ADDENDUM NO. 1

**Chouteau County Airports**  
**Big Sandy A.I.P. 3-30-0006-006-2017**  
**Fort Benton A.I.P. 3-30-0030-011-2017**  
**Chouteau County, Montana**

This addendum modifies the *Contract Documents & Specifications* as well as the *Bidding Documents* for the Chouteau County Airport Improvements Project for Chouteau County, Montana, as set forth herein:

**3. Big Sandy - Construction Drawings, Sheet E-4, Figures**

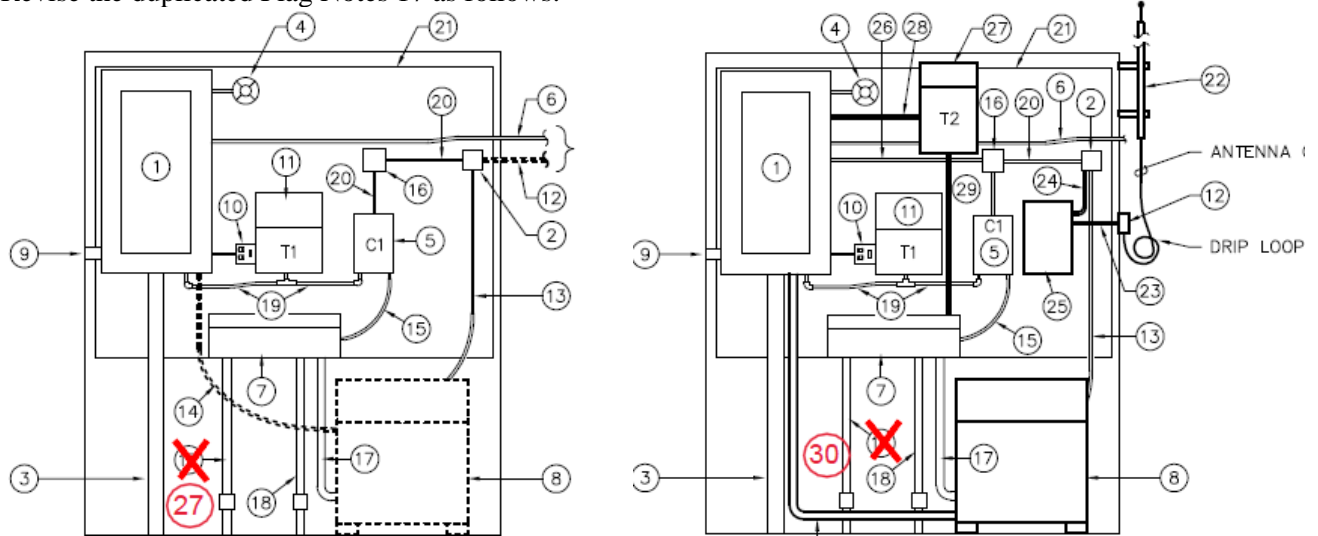
Revise the duplicated Flag Notes 17 as follows:
